City of
Richmond

Report to Development Permit Panel

To: Development Permit Panel
From: Wayne Craig
Director, Development
Date: June 15, 2023
File: DP 21-936427
Re: **Application by Kadium No. 4 Development Ltd. for a Development Permit at 10340, 10360, 10380, 10400 and 10420 No. 4 Road**

Sheet Title
LOCK-OFF UNIT
FLOOR PLANS

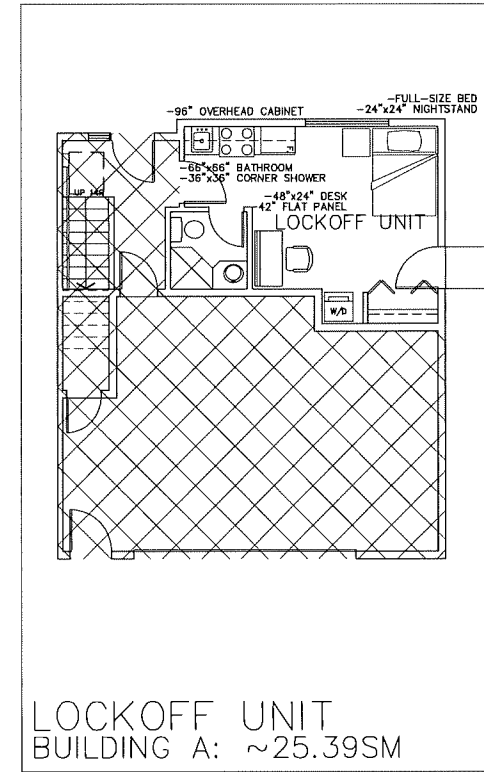
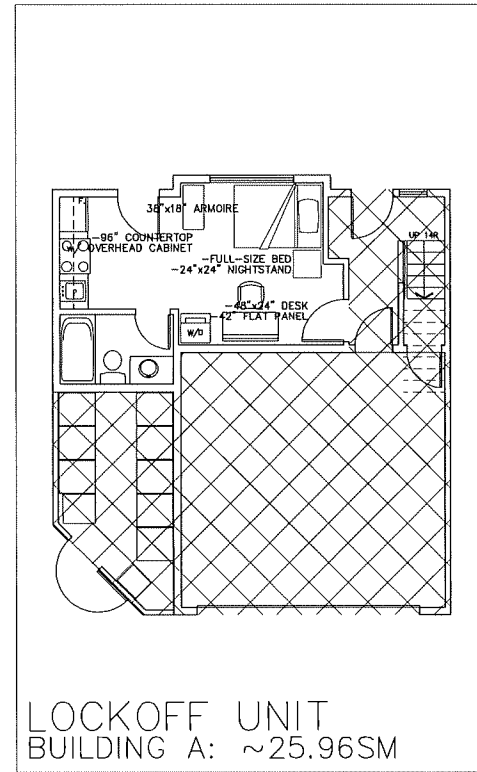
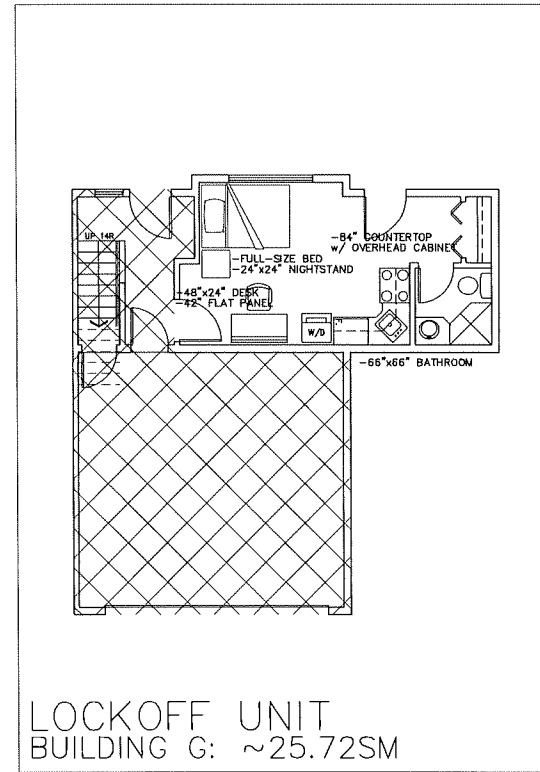
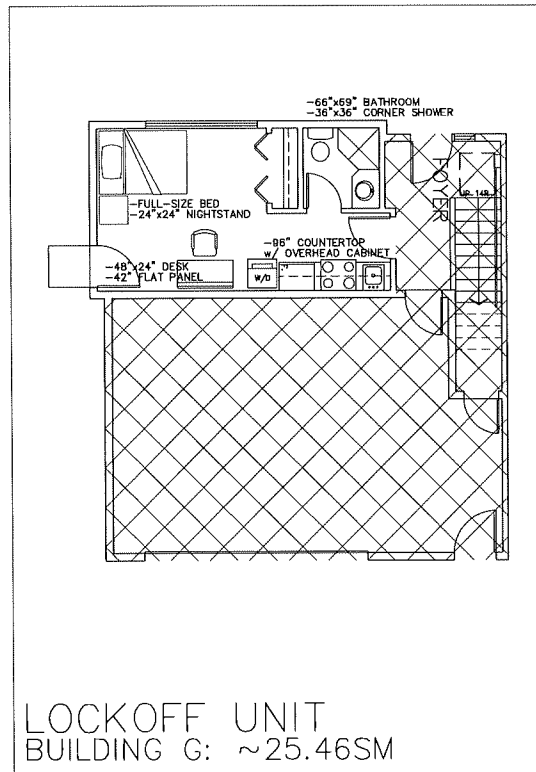
- appreciate the idea of lock-off units; however, there is no provision for a washer and dryer or closet in one lock-off unit; consider providing more uniform features for the lock-off units; ***W/D unit added to lock off units.***
